**BELL BEND NUCLEAR POWER PLANT
RESPONSE TO RAI SET 1
BNP-2009-122 Docket No. 52-039**

This RAI addresses Basic Geologic and Seismic Information, as discussed in Section 2.5.1 of the Final Safety Analysis Report (FSAR), as submitted in Part 2 of the Bell Bend Nuclear Power Plant Combined License Application (COLA).

Response to NRC Request for Additional Information Set No. 1
Bell Bend Nuclear Power Plant

Figure 2.5-182 (Physiographic Provinces of Pennsylvania (Geologic Map of Pennsylvania) 25 Mile (40 km) and 5 Mile (8 km) Radii)

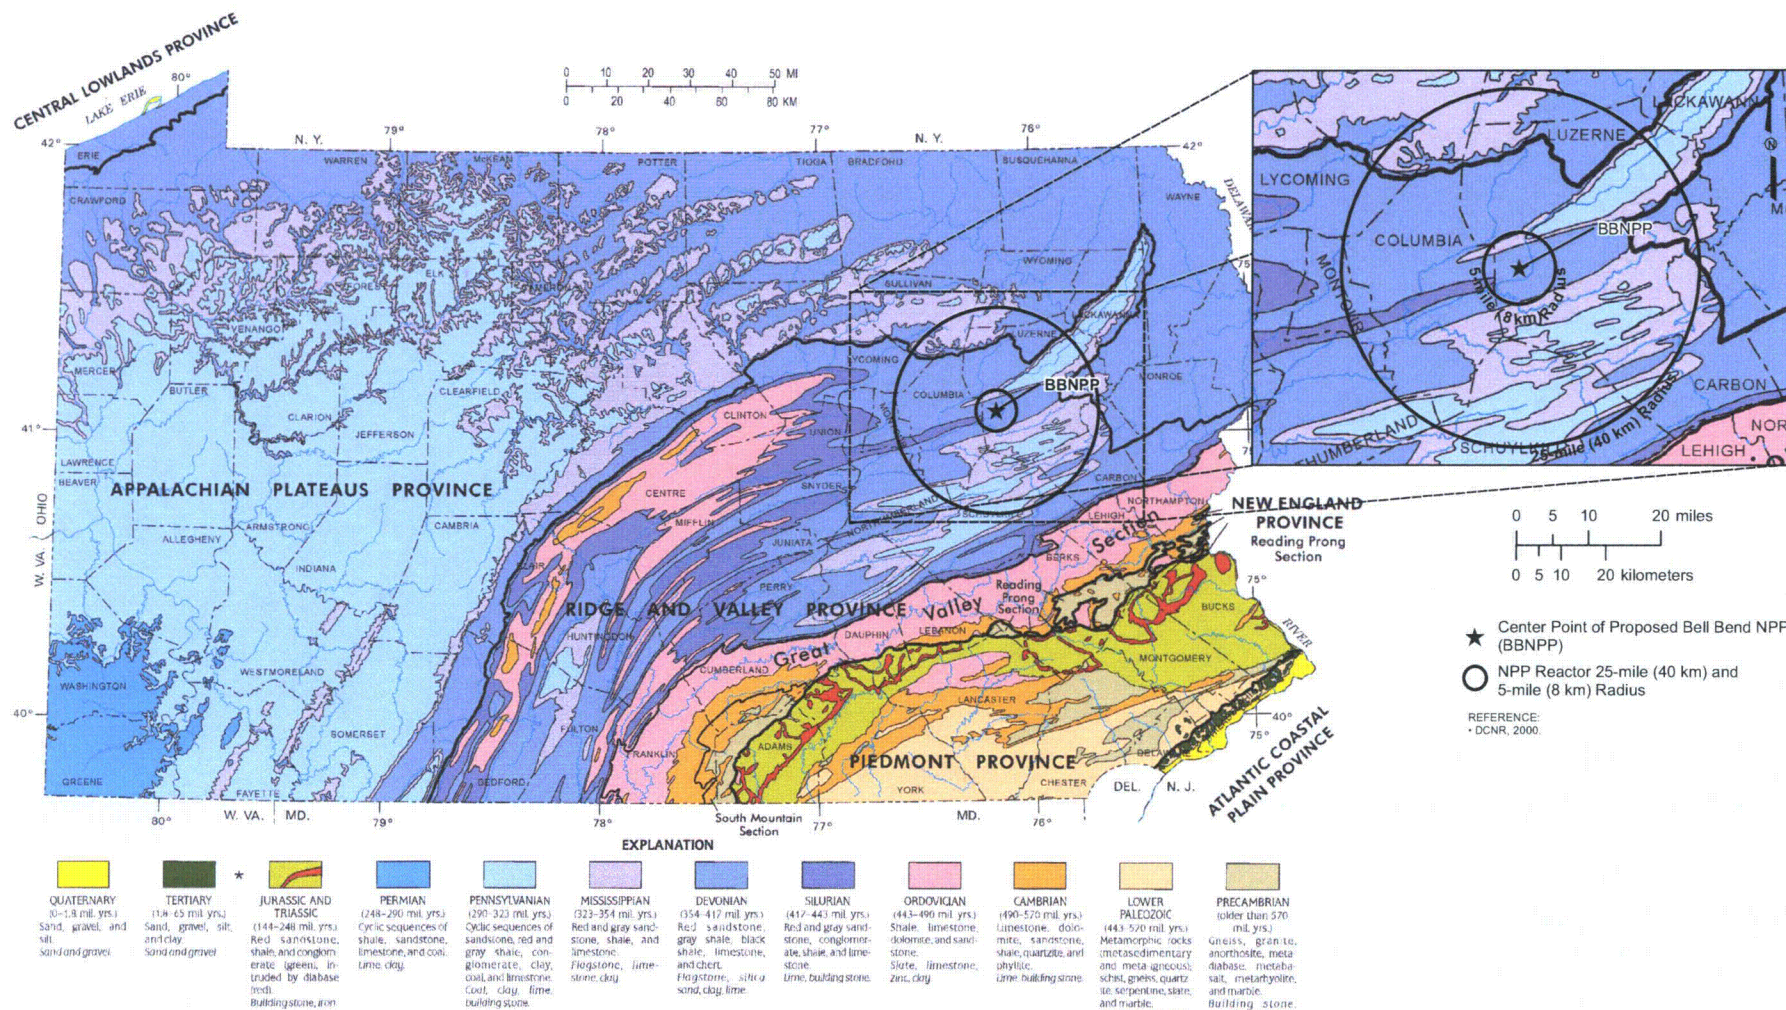
FSAR Section 2.5.1 provides Figure 2.5-6 as a geologic map for the 25 mile or 40 km radius of the BBNPP site. The application refers to Figure 2.5-6 many times throughout the Chapter. This map is a cut-out or excerpt of a general state geologic map of Pennsylvania. In order for NRC staff to understand the presentation in the text of the regional and vicinity level discussions for geologic history, stratigraphy and structural/tectonic features as they relate to the Bell Bend site, the staff needs a map that is more detailed and has higher resolution than Figure 2.5-6. Please provide such a geologic map, with an appropriate scale, to show additional detail for the vicinity of the BBNPP site. An appropriate scale is one such that a new reader can examine the geologic map and see that the relationship that is being described in the text is in fact corroborated by the mapping.

Figure 2.5-6, Physiographic Provinces of Pennsylvania (Geologic Map) with Sections 25 Mile (40 km) and 5 Mile (8 km) Radii, as submitted in Letter BNP-2008-006, has been incorporated into Revision 1 of the COLA as Figure 2.5-182. Revision 1 of the COLA also includes three additional figures that were not included in Revision 0 that provide further detail. The cut-out area identified on Figure 2.5-182 was further expanded in the following figures:

Additionally, the references to Figure 2.5-182 (Figure 2.5-6 in COLA Revision 1) in Section 2.5.1 have been updated in Revision 1 to refer to the more detailed versions of the figures, where appropriate.

Figure 2.5-208 (Mesozoic Basins and Associated Known Faults)

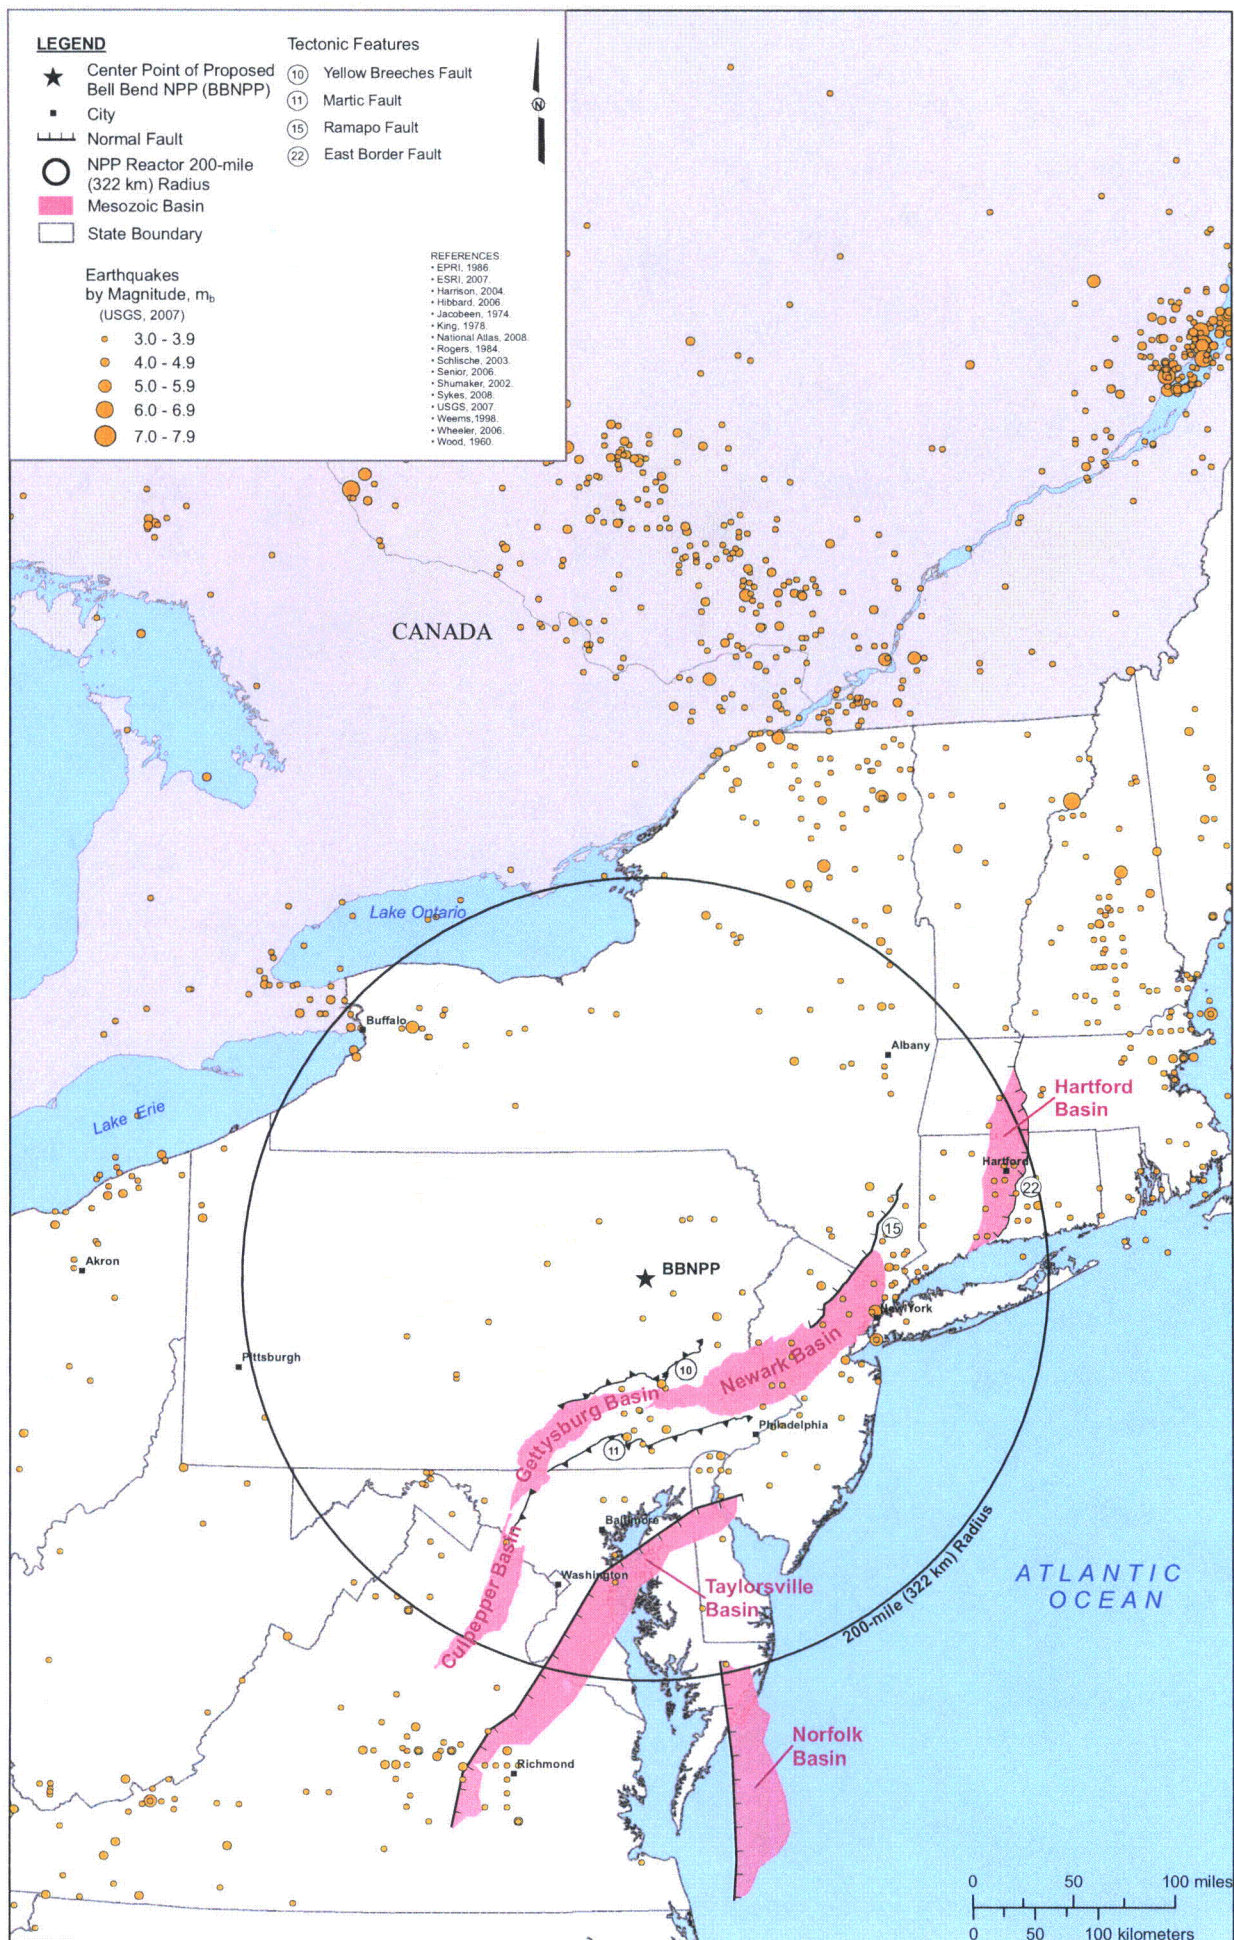
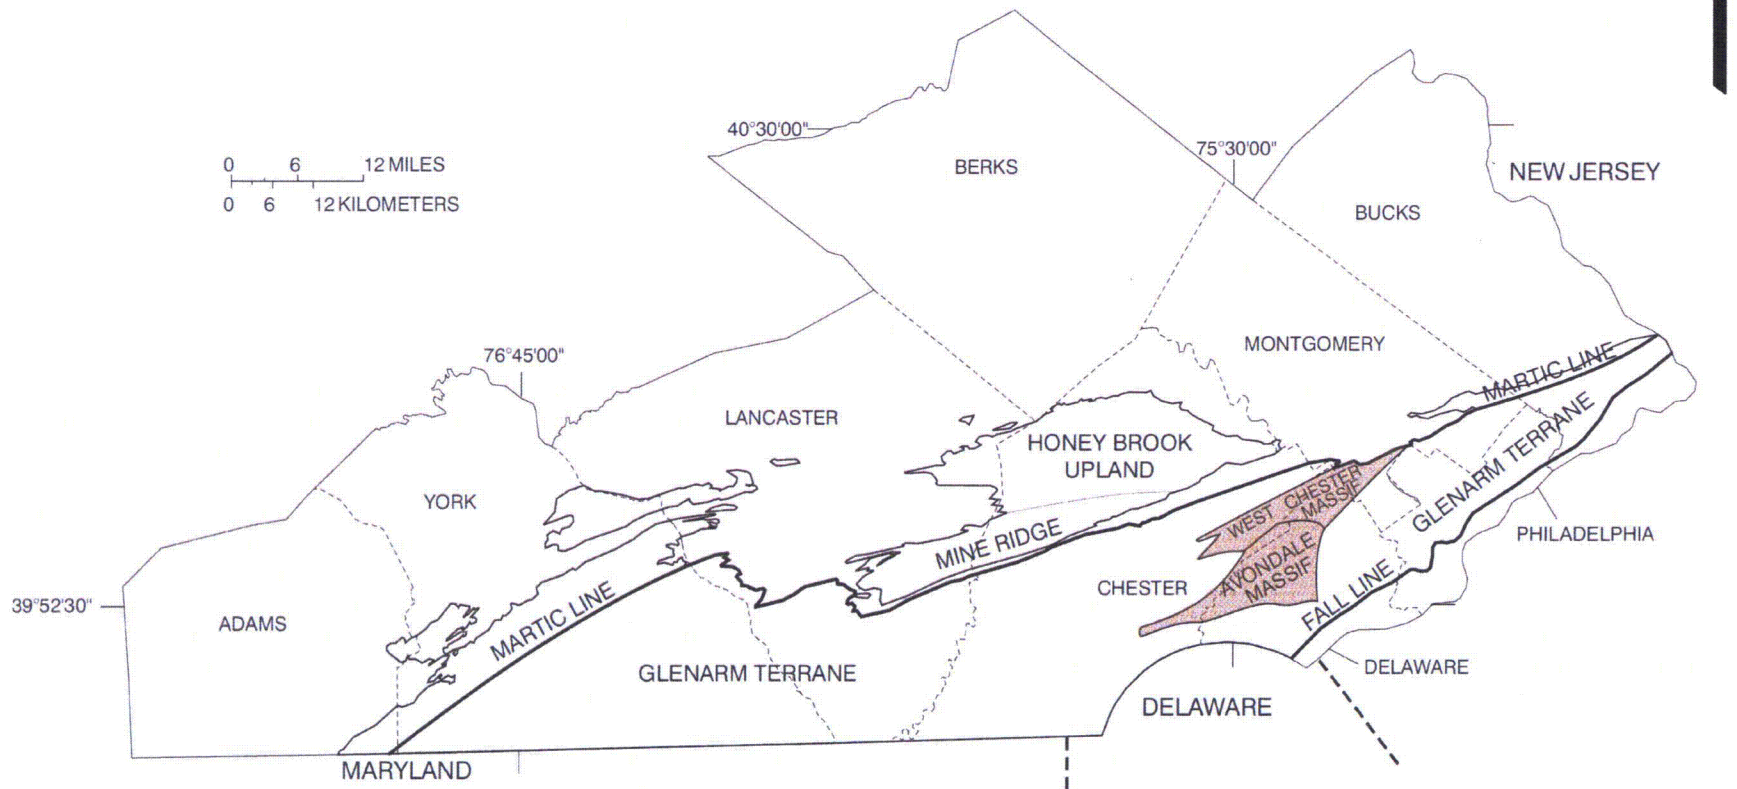
FSAR Section 2.5.1.1.2 (starting on page 23 of BNP-2008-006 Attachment 1) provides a discussion about the regional geologic history around the BBNPP. Please provide a clear, distinct discussion of the development of the tectonic provinces of the Blue Ridge, Piedmont and Mesozoic rift basin provinces and the tectonic features within these provinces. Please discuss the terranes that occur within a 200-mile radius of the BBNPP site, including the Grenville-aged Avondale and West Chester Massifs, the Taconic and Alleghanian terranes such as the Philadelphia Structural block and associated shear zones, and the Westminster, Baltimore, and Reading Prong Provinces.

Revision 1 of FSAR Section 2.5.1.1.2.7, Early Mesozoic Extensional Episode (Triassic Rifting), will be revised as part of a future revision to the COLA to provide a more detailed description. Additional Mesozoic Rift Basins were included on Figure 2.5-208, Mesozoic Basins and Associated Known Faults. Generalized rift basin structures are described on Figure 2.5-212, Generic Distribution of Structures and Features in Mesozoic Rift Basins. The additional descriptive text and the new and amended figures are included in the following pages.

Subsequently, the basins were filled with sediments such as conglomerates, sandstones and shales and exhibit evidence of syn-rift deposition (lessening of offset upward in the basin deposits) (Schlische, 2002). The Culpepper, Gettysburg, and Newark, Hartford, Taylorsville, and Norfolk Basins lie within or close to the outside limit of the site region (200 mi (322 km) radius and are shown on ~~Figure 2.5-190~~ Figure 2.5-208.

Figure 2.5-208 {Mesozoic Basins and Associated Known Faults}

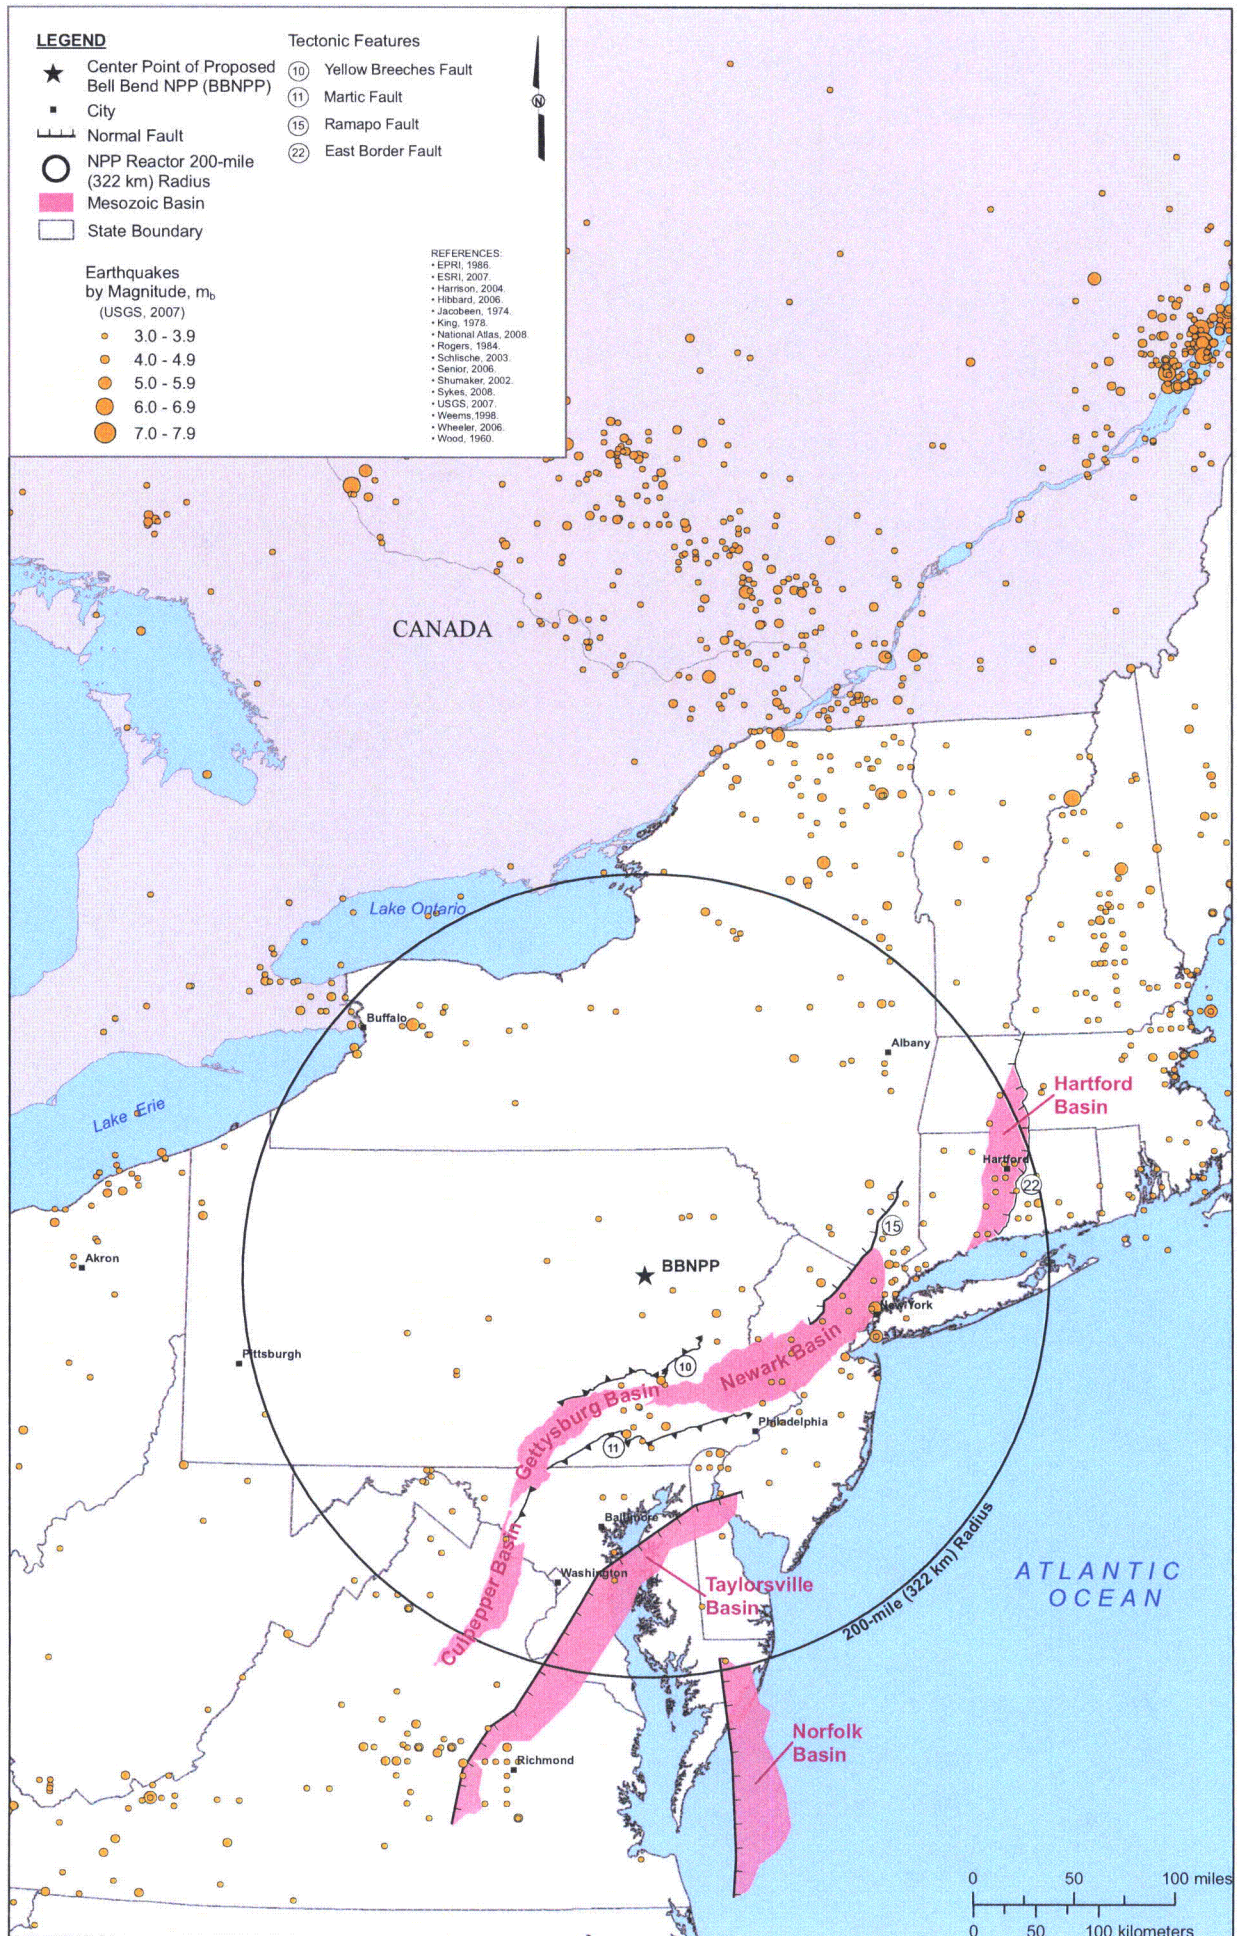
FSAR Section 2.5.1.1.4 (BNP-2008-006 Attachment 1 - Page 34) provides a discussion about the Regional Tectonic Setting. Figure 2.5-15 (BNP-2008-006 Attachment 1 – Page 337) frequently referred to in that section has too many different types of features crowded together on a regional scale map and is difficult to read. In order for the NRC staff to evaluate all the tectonic features within a 200 mile radius of the BBNPP, please revise Figure 2.5-15 for clarity and add other figures showing more detailed scale maps to support specific discussions in the text. Specifically:

1. Separate the EPRI tectonic interpretations and illustrate them on their own maps. (EPRI tectonic interpretations are generic and not a replacement for geologic/tectonics structure maps.)
2. Provide a separate illustration of seismic source zones.
3. Provide a separate figure with all Mesozoic basins (exposed, covered, and offshore) within the regional radius and the associated faults that are known.
4. Provide a separate figure for potential field features in greater detail than shown generically in Figure 2.5-15, and include the underlying potential field data and the interpretation.
5. Indicate the age of the structures (e.g. PC, Pz, Mz, Cz) where possible.

3. Figure 2.5-190, Regional Tectonic Basins with Gravity and Magnetic Anomalies, identifies the Mesozoic basins within the region. An additional figure has been provided as Figure 2.5-208, Mesozoic Basins and Associated Known Faults, which identifies the Mesozoic basins within the regional radius and the associated faults. This figure will be incorporated into the FSAR in a future revision.
